LOCAL REVIEW BODY

PLANNING APPLICATION FOR REVIEW

**PROPOSED ERECTION OF RAISED DECKING AND BOUNDARY FENCE:
3 CARDROSS PLACE, GREENOCK (17/0186/IC)**

FIRST FLOOR PLAN AS PROPOSED

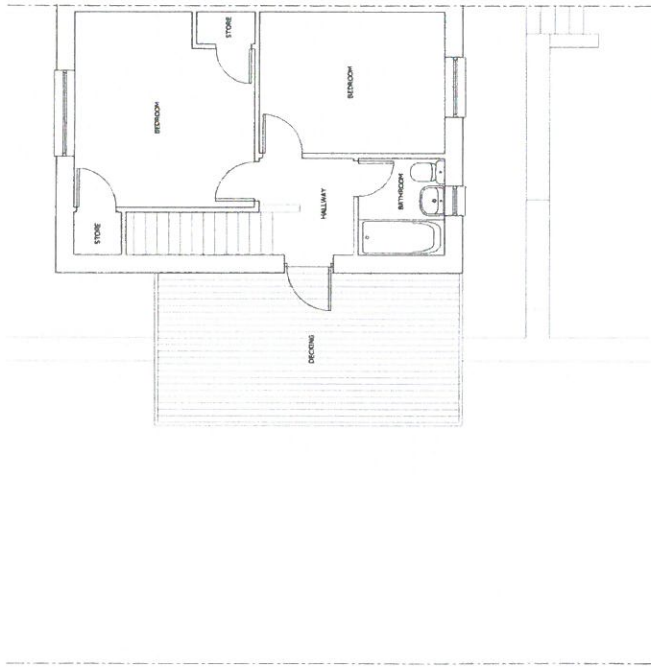
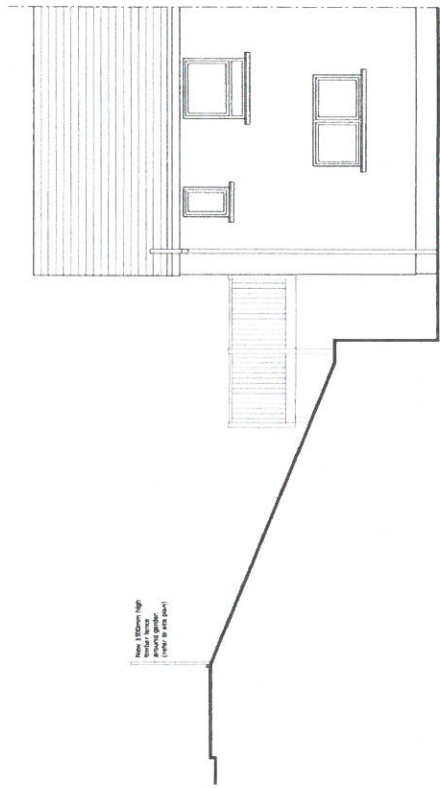
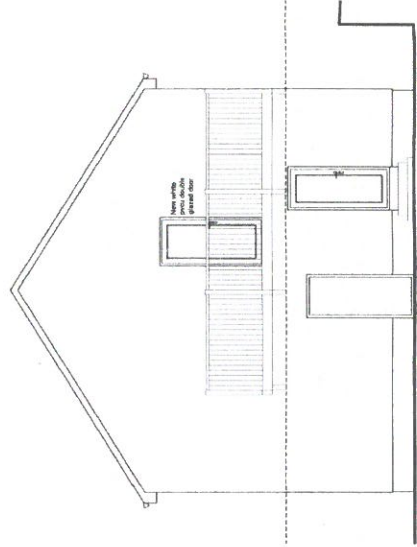
Planning permission is sought to erect decking on the upper storey southern side elevation of the house. Owing to the topography of the site the proposal would bridge an existing pathway which leads to the rear garden and involve construction and support posts to be fixed into the adjoining steeply sloping grass embankment lying between the property and its southern boundary with Clynder Road. The decking floor level will be approximately 3 metres in height above ground level and it will cover around 18 square metres. A 1.5 metre high open slatted timber fence is proposed to be constructed around the site covering the entire southern side and the western corner fronting Cardross Place.

1. The design and position of the raised decking has a detrimental impact on the streetscape and the character and amenity of the area, contrary to Policy RES1 and Policy RES5 of the Inverclyde Local Development Plan.
2. The position and height of the boundary fence has a detrimental impact on road safety at the junction of Cardross Place and Clynder Road, contrary to Policy RES5 of the Inverclyde Local Development Plan.

PROPOSED SITE PLAN SCALE 1:200

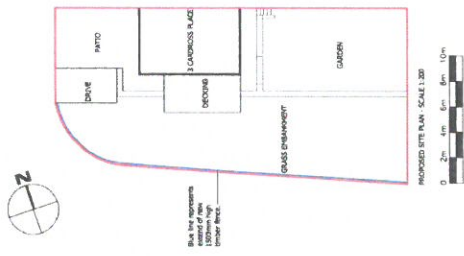
1.	The proposed new fence will replace an existing fence. The new fence line is on the boundary line of the property which is different from the existing fence. The visibility splay from Cardross Place to Clynder Road appears to be 2.4m by 30.0m with the new fenceline. This is acceptable as traffic is likely to be travelling slowly from the deadend on Clynder Road towards Cardross Place.
2.	The new fence also continues up to the driveway. The type of fence proposed provides no visibility of pedestrians on the footway or vehicles entering Cardross Place from Clynder Road. This is not acceptable. The applicant should lower the fence to 1.0m high from the driveway for a distance of approximately 4.0m.

Reference to these comments in the Report of Handling (Appendix 7) made by the case officer state that the advice is to lower the fence to 1.0 metre in height for a distance of 40metres from the driveway. The lowered height will only intensify the concerns regarding visibility of the proposals as well as overlooking/privacy implications. The distance of 40 metres is incorrect and should only be 4 metres. If the fence was only reduced over a distance of 4 metres, then the 1500mm high fence erected over the remainder of the side garden will still provide screening and assist with providing privacy from the street. Any pedestrians using the pavement on Clynder Road are unlikely to see the decking due to the height of the fence.
